Reference: Engineering Services
4934 Red Hill Church Road
Coats, NC 27521
TE&D Project No.: 2301-020663

As requested, a representative of Tyndall Engineering & Design, PA (TE&D) was on-site to observe the following items:

- 1) Inadequate footing projection at (2) piers within foundation.

Examples and locations of piers with inadequate footing projection

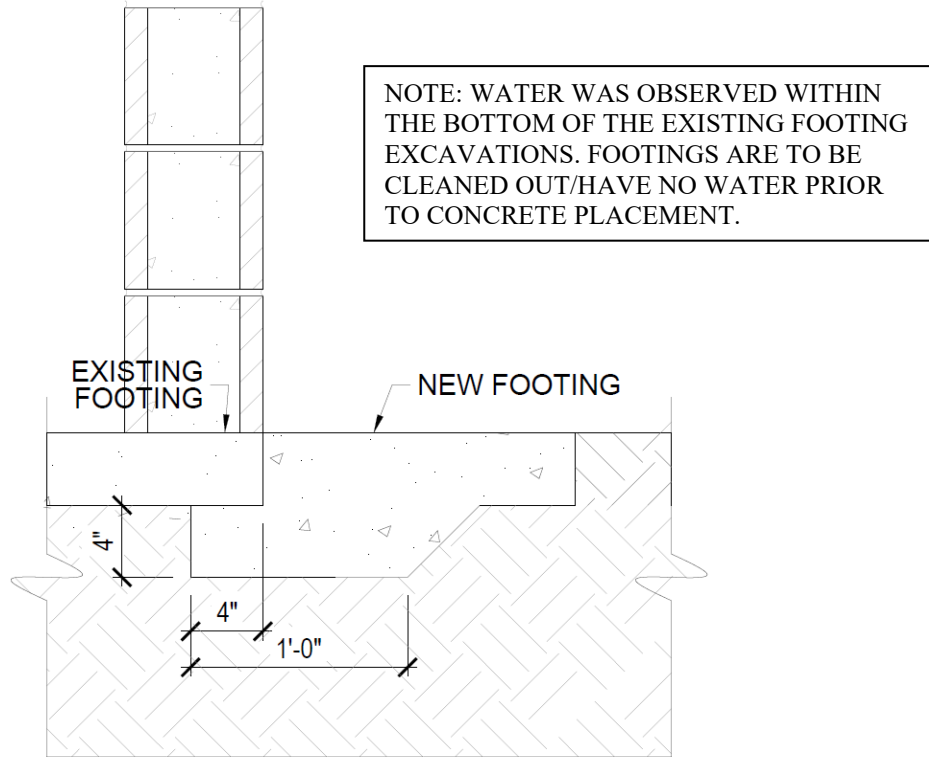
- 1) Based on our visual observations and analysis, the existing foundation did not have a suitable projection of at minimum 2". It was observed that the footing was flush with at least (1) face of (2) piers at the left side of the foundation. TE&D recommends widening the existing footing in these locations per (1) of the details on page 3 of this report.
